INFORMATION LETTER 206L-08-84

TO: All Owners/Operators of Bell 206L Series Helicopters

SUBJECT: MAST NUT 206-040-078-103, INSPECTION AND RECALL OF

Figure 1. Mast Nut 206-040-078-103, physical difference

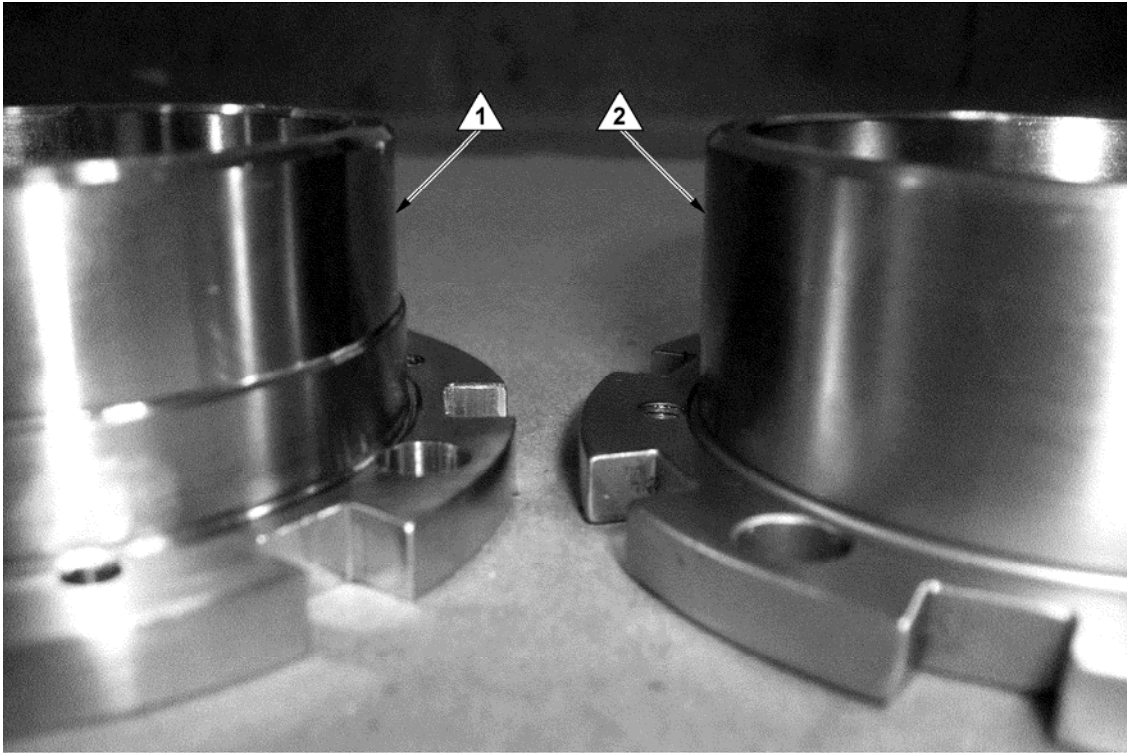
This information letter is issued to report that some mast nuts 206-040-078-103 were delivered with a step adjacent to the mast nut flange (refer to Figure 1). This condition is not considered detrimental to the normal operation of the helicopter. However, Bell Helicopter recommends that affected installed or in spare stock mast nuts that are identified, be replaced whenever practical. Installed mast nut can only be identified at mast disassembly.

- 1** Unacceptable mast nut to be removed from service.
- 2** Acceptable mast nut with no step.

Bell Helicopter will supply replacement nut at no charge: To receive this credit, purchase the replacement nut from an approved BHTI supply source. Submit a completed MMIR to BHTI Warranty Department no later than 90 day after the replacement nut is installed in your aircraft or replaced in your stock.
